PCN-20190711 TEC0850-03-* SPI Flash Change

Company	Trenz Electronic GmbH
PCN Number	PCN-20190711
Title	TEC0850-03-* SPI Flash Change
Subject	BOM change
Issue Date	2019-07-15

This change affects all Trenz Electronic TEC0850-03 SoMs: TEC0850-03-*

Locate Flash (U24 and U25) on top side of PCB:

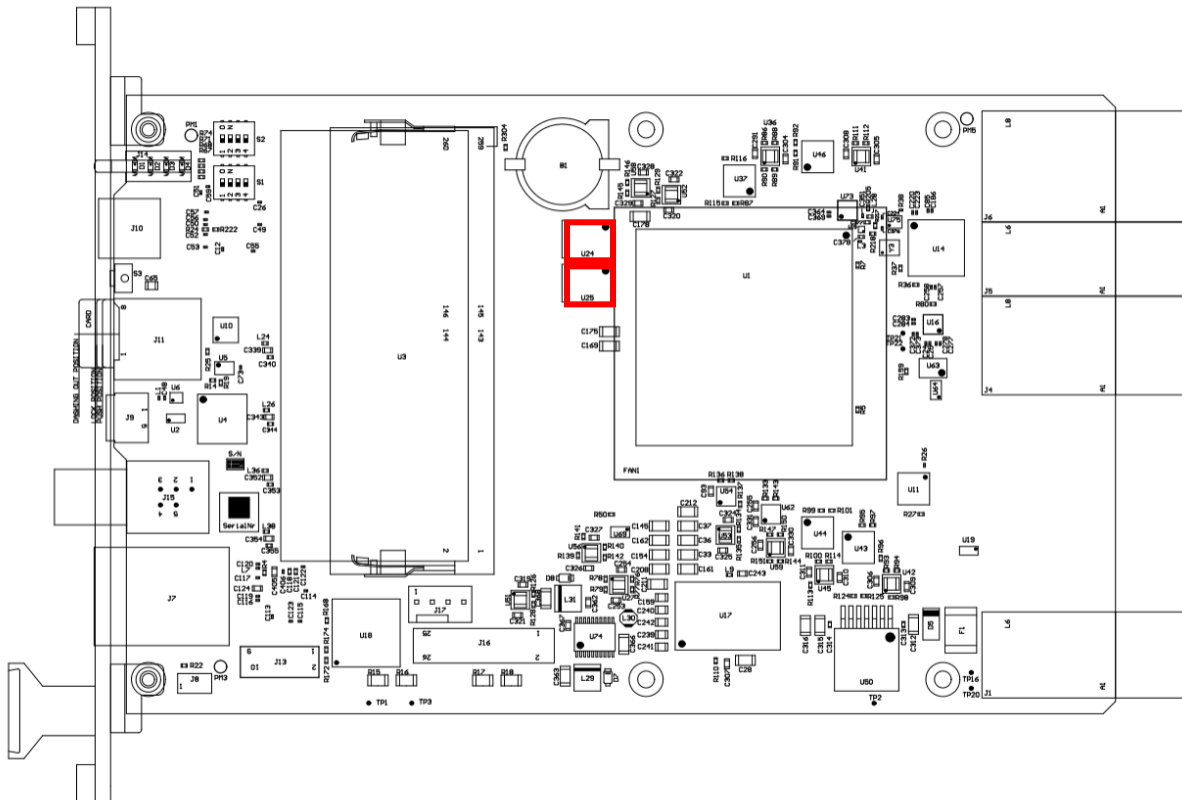
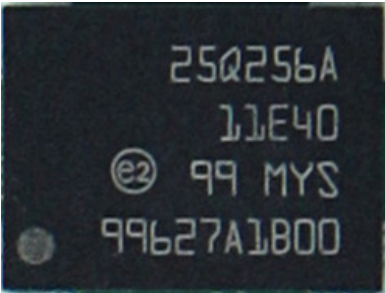
#1 Change SPI Flash from N25Q512A11G1240E to MT25QU512ABB8E12-0SIT

Reason: N25Q512A11G1240E became obsolete.

Impact: None. Both have same JEDEC ID BB20h and manufacturer ID 20h.

old	new
N25Q512A11G1240E	MT25QU512ABB8E12-0SIT
